**Project Name:** 10 Hazelmount Street  
**Client Name:** Focus Construct  
**PSA Project Number:** 2020  
**Report Name:** Traffic Engineering Advice  
**Attention:** Todd Dunlop

**PLANS AND DOCUMENTS**  
 referred to in the PDA  
 DEVELOPMENT APPROVAL

Approval no: DEV-2026-BNH-4193

**AMENDED IN RED**

SWEPT PATH ANALYSIS - GROUND FLOOR (RIGHT OUT) - MRV  
FOCUS DEVELOPMENTS NO1  
TRAFFIC ENGINEERING ADVICE  
10 HAZELMOUNT STREET, BOWEN HILLS QLD 4006

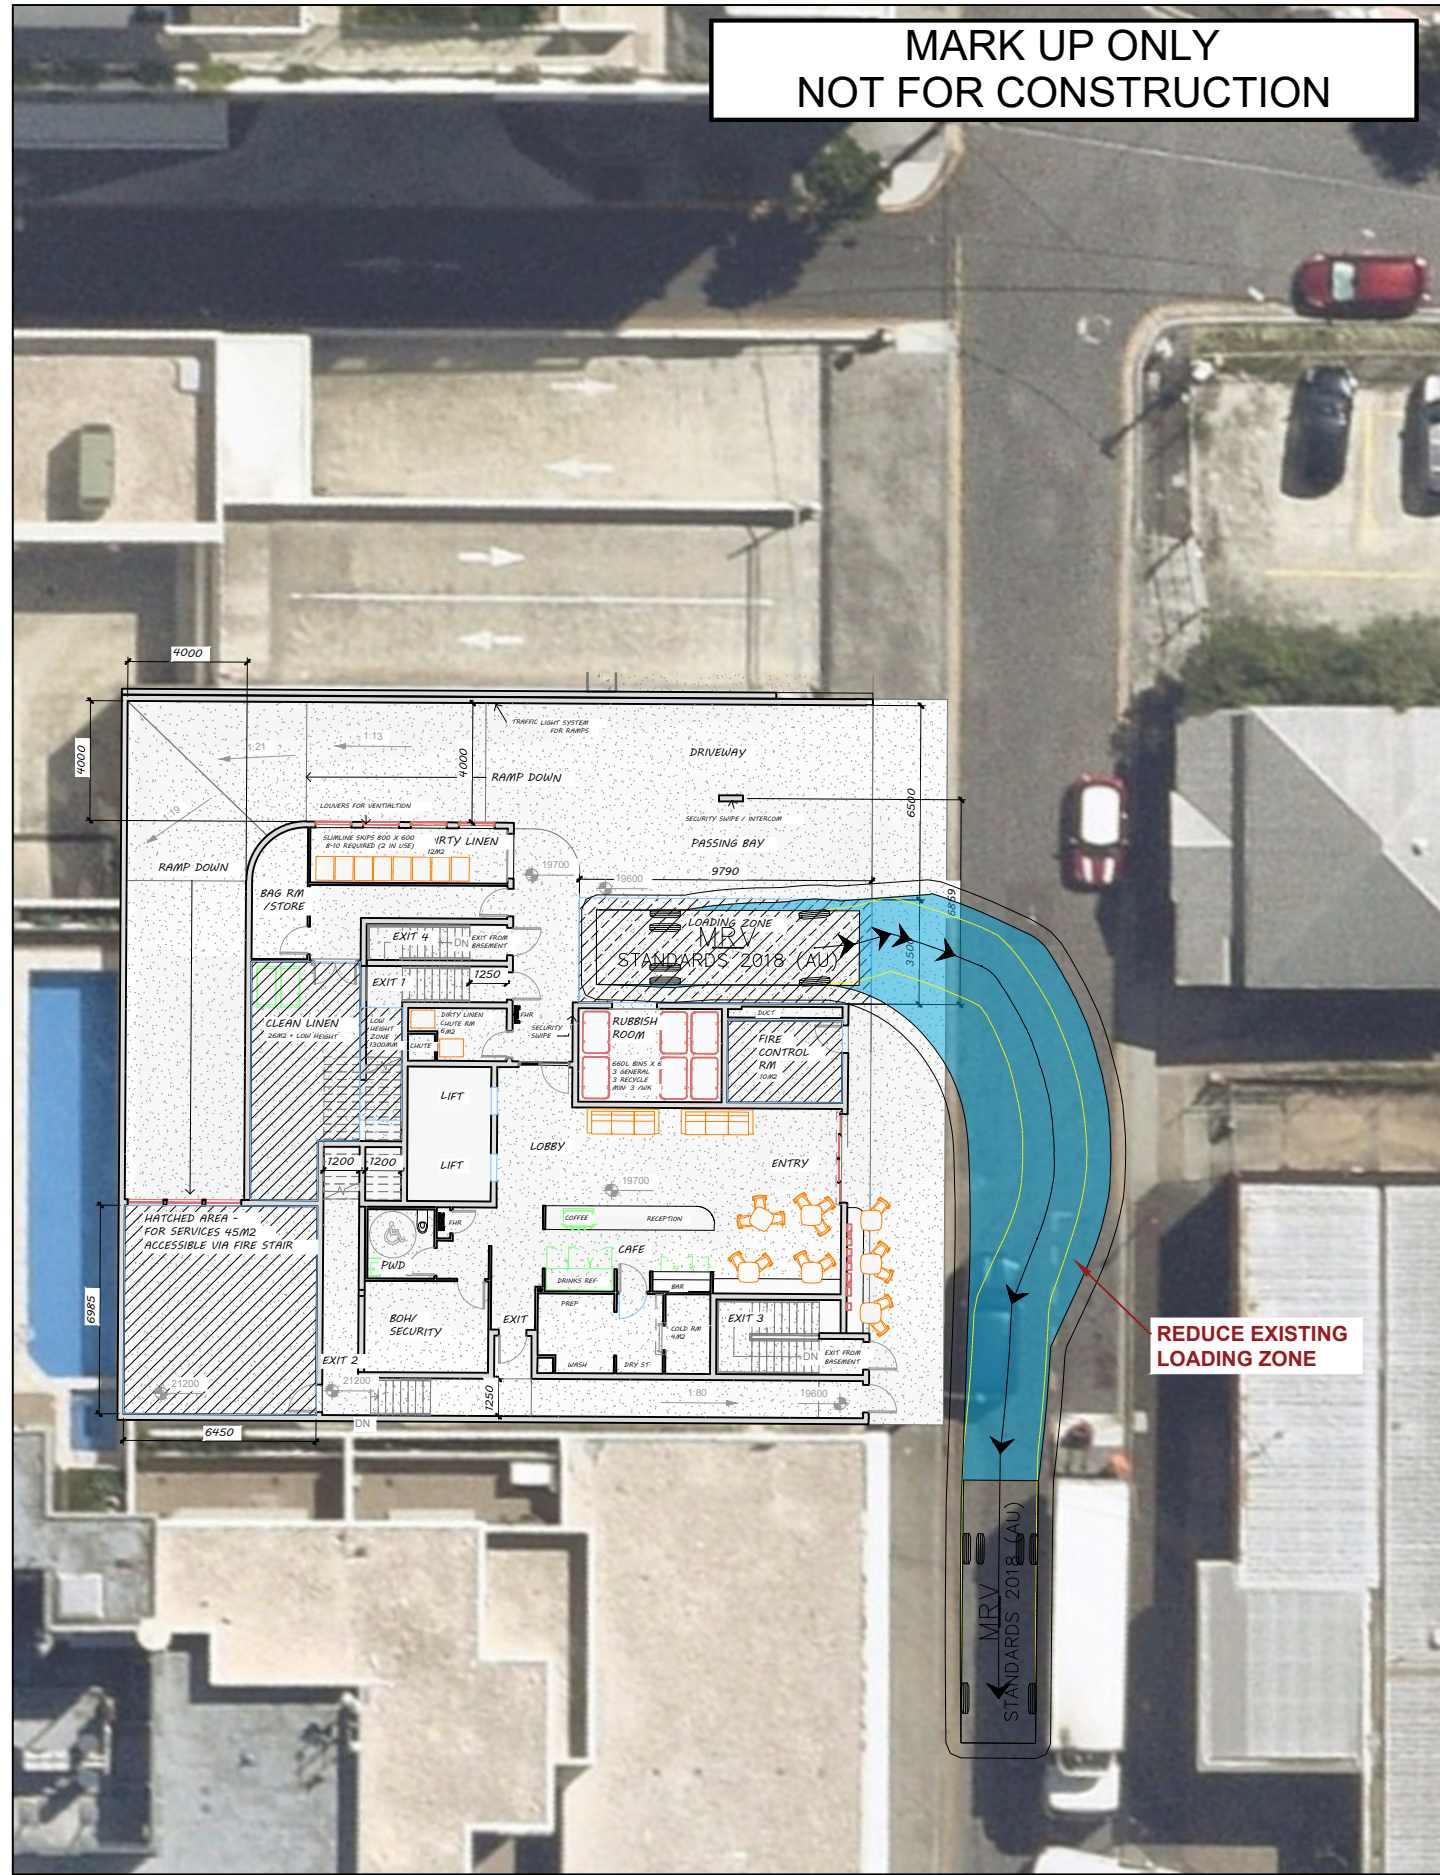
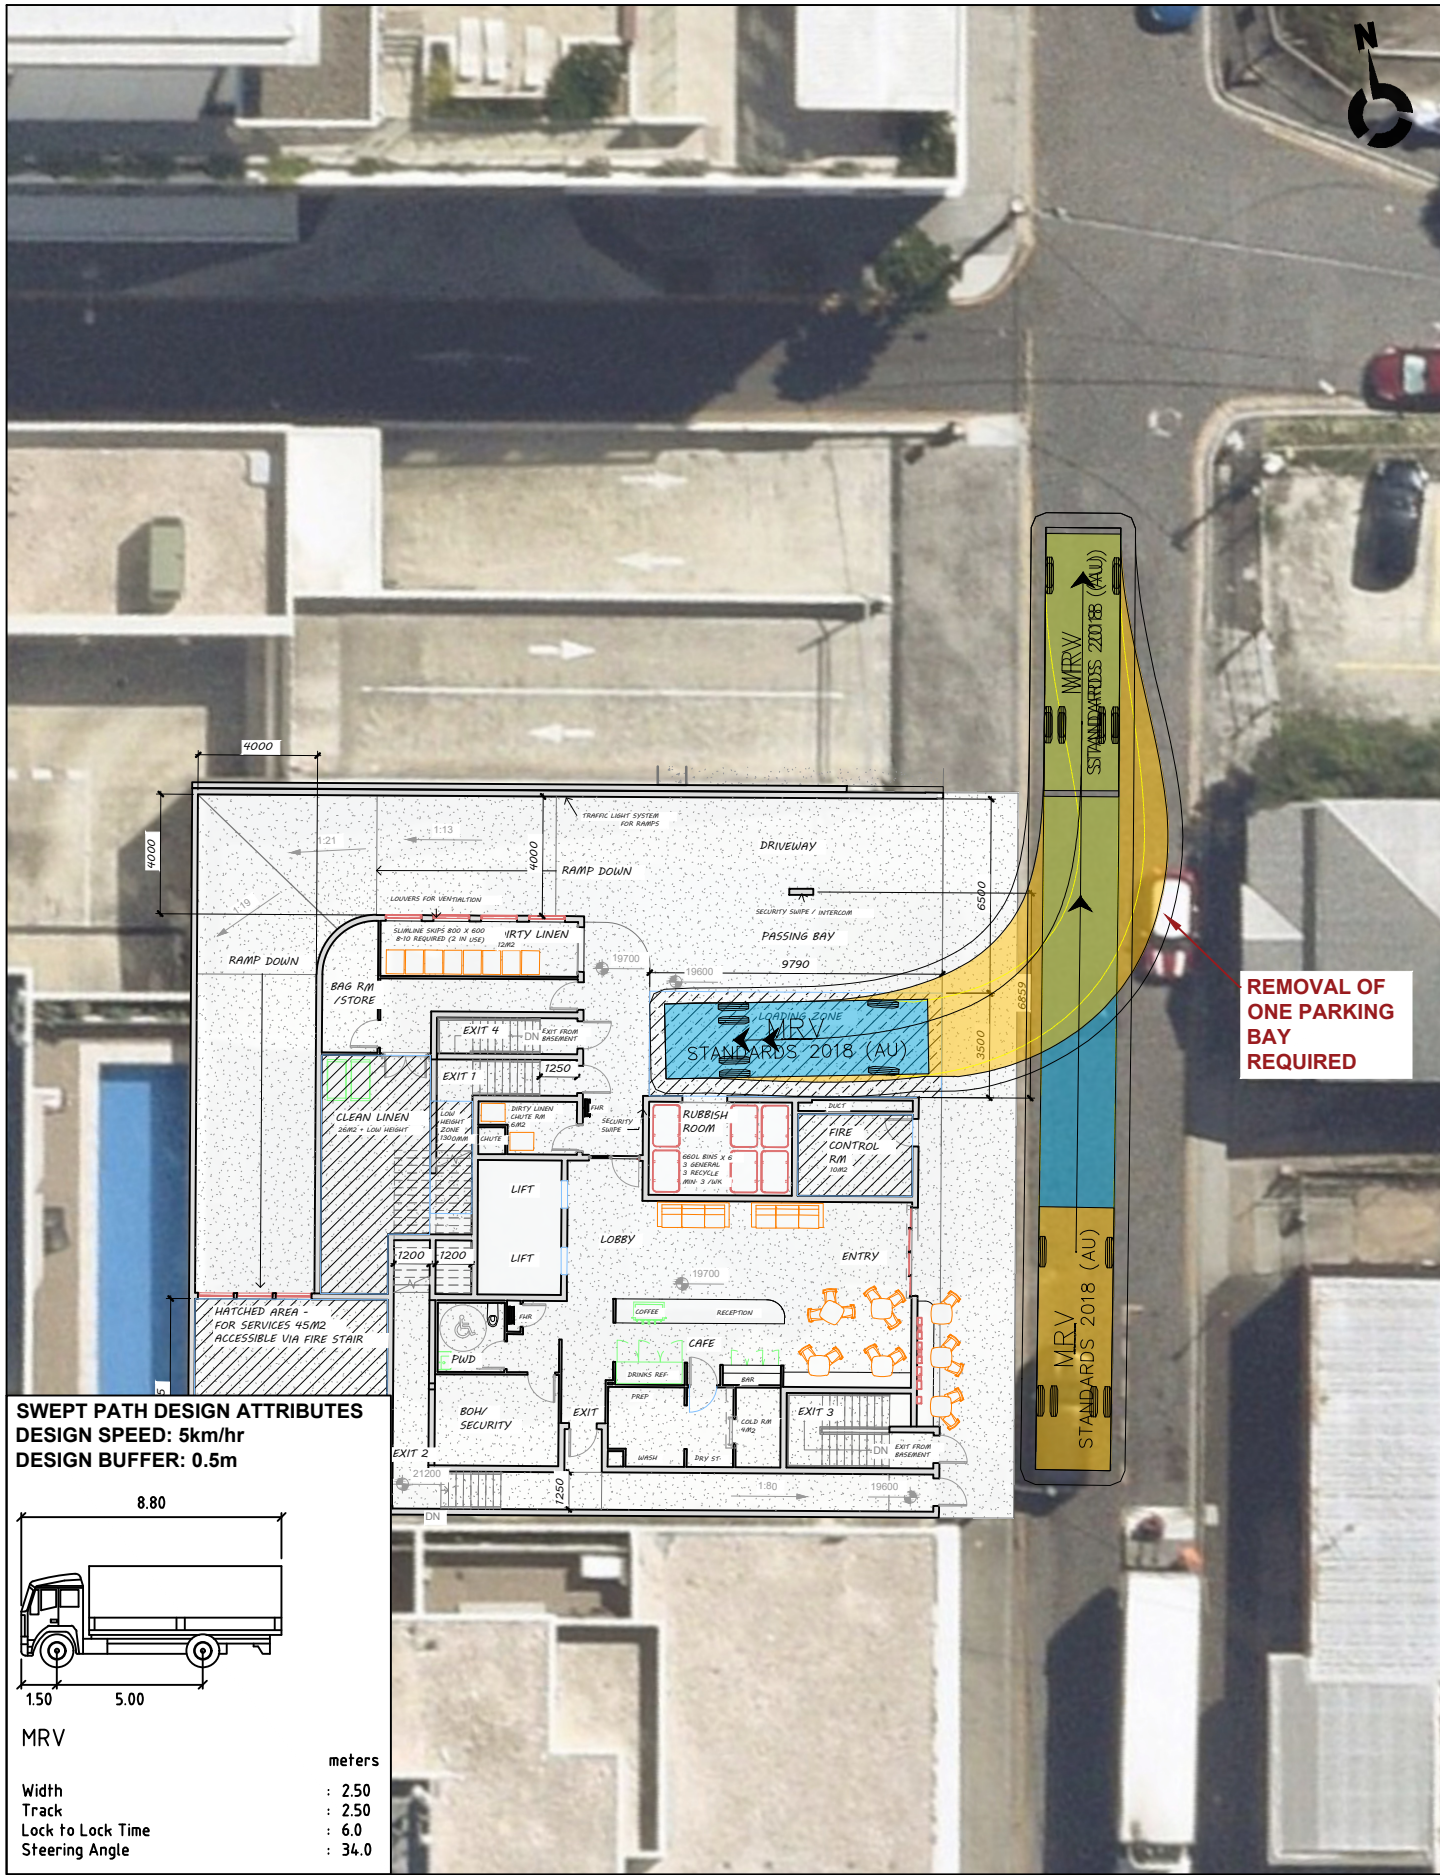
Upon exiting the service bay, minor encroachment into the existing loading zone opposite the development (to the south) occurs when an MRV undertakes a right-turn manoeuvre. ~~This encroachment is limited, requiring a reduction of approximately 3.5 metres from the existing loading zone. This is considered minor, as approximately 17 metres of loading space would remain available. This residual length is adequate to accommodate large or medium vehicles, or multiple smaller vehicles. To further mitigate this interaction,~~ operational measures ~~to~~ be implemented, including restricting MRV movements to a left-in / left-out arrangement. Under this scenario, vehicles would utilise Edgar Street for onward travel following servicing, thereby avoiding the need for right-turn movements and eliminating potential conflicts with the opposing loading zone. Full details of swept path analysis are included in Appendix 2.
